LIBERTY SUBDIVISION

APPLICATION NUMBER 16 DATE December 15, 2011

DETAIL SITE PLAN

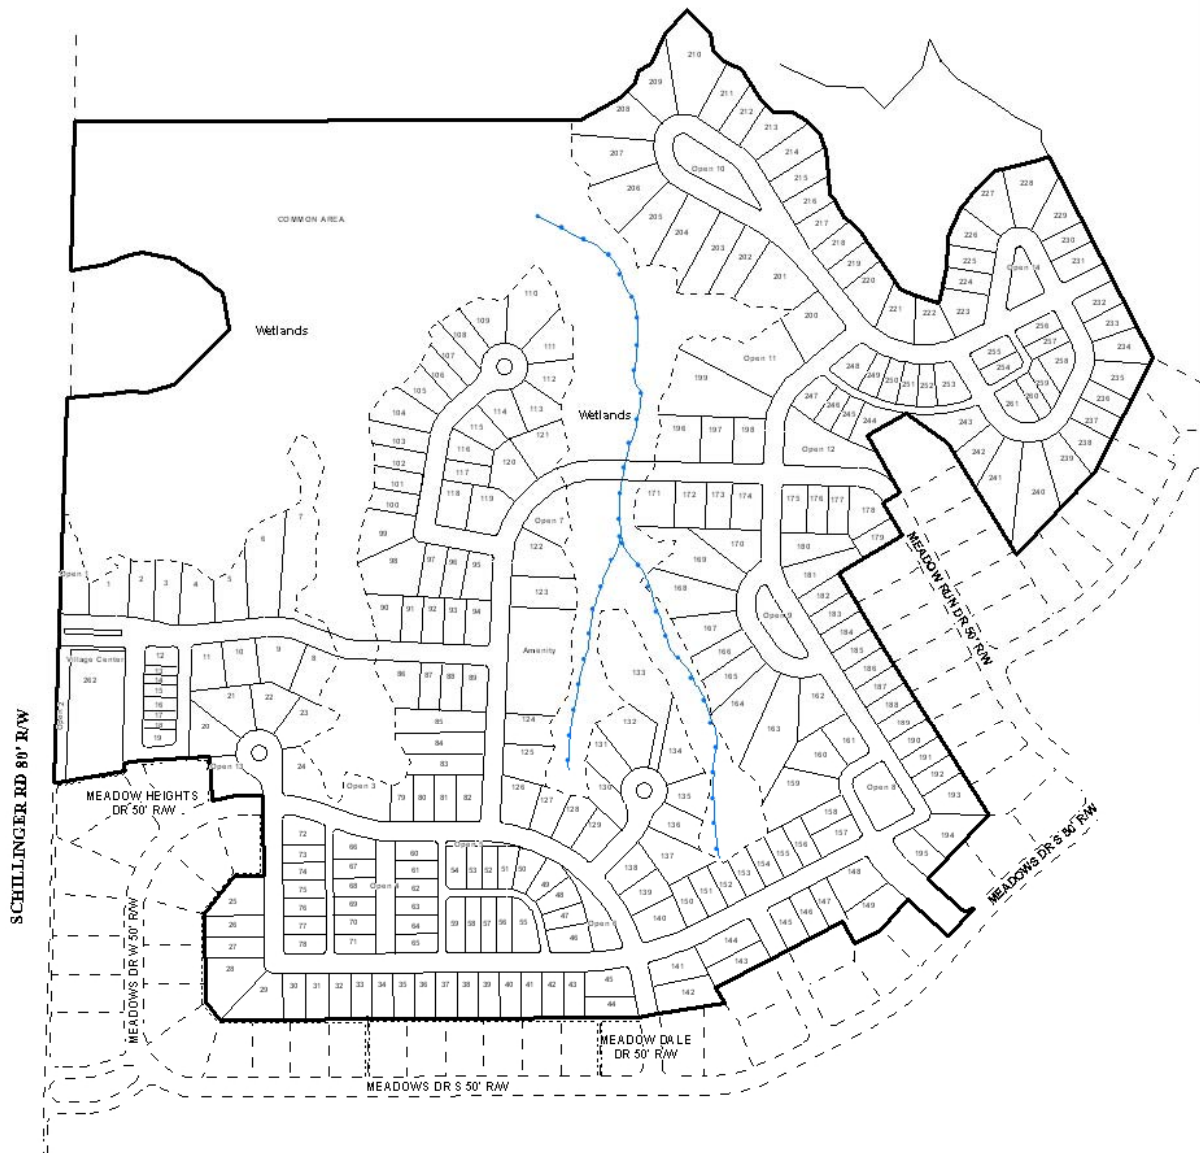
The proposed subdivision has frontage onto street stubs for The Meadows subdivision, all minor streets with adequate rights-of-way, and Schillinger Road South, a proposed major street with an existing right-of-way width of 80 feet. As Schillinger Road South is a proposed major street, its right-of-way should be 100-feet in width, thus sufficient right-of-way should be dedicated to Mobile County to provide 50 feet, as measured from the centerline of Schillinger Road South. With that said, the 25-foot minimum building setback line for all lots with frontage onto Schillinger Road South should be revised to reflect the right-of-way dedication.

Access management is a concern regarding the proposed subdivision fronting onto a proposed major street, and as it relates to lots within the proposed subdivision. One access to Schillinger Road South is depicted on the preliminary plat; therefore, a note should be placed on the plat stating that direct access to Schillinger Road South is denied for any lots fronting onto Schillinger Road South. Moreover, all lots are illustrated as being contained within the subdivision; therefore, a note should be placed on the plat stating that all lots (including corner

It should be noted that Lots 7, 56-58, 84, 85, 133, 163, 164, 169 and 240 appear to exceed the maximum depth allowed by Section V.D.3 of the Subdivision Regulations. However, given the close proximity of the site to wetlands, much of the rear of these lots may not be developable; thus, a waiver may be appropriate.

The site plan depicts several open areas and detention basins. A note should be placed on the Final Plat, if approved, stating that maintenance of the Common Area/Detention Area, and any other common areas, are the responsibility of the development's property owners.

- 1) dedication of sufficient right-of-way to provide 50', as measured from the centerline of Schillinger Road South;
- 2) the placement of ALL building setbacks and a table illustrating ALL setbacks on the Final Plat;

- 3) the placement of a typical lot setback for ALL size of lots to be illustrated on the Final Plat;
- 4) placement of a note on the Final Plat stating that direct access to Schillinger Road South is denied for any lots fronting onto Schillinger Road South;

- 5) the labeling of each lot with its size in square feet and acres, or the placement of a table on the Final Plat with the same information;
- 6) placement of a note on the Final Plat stating that all lots (including corner lots) are limited to one curb each, with the size, design and location to be approved by the Mobile County Engineering Department and in conformance with AASHTO Standards;

- 9) the placement of a note on the Final Plat, stating that maintenance of the Common Area/Detention Area, and any other common areas, are the responsibility of the development's property owners;
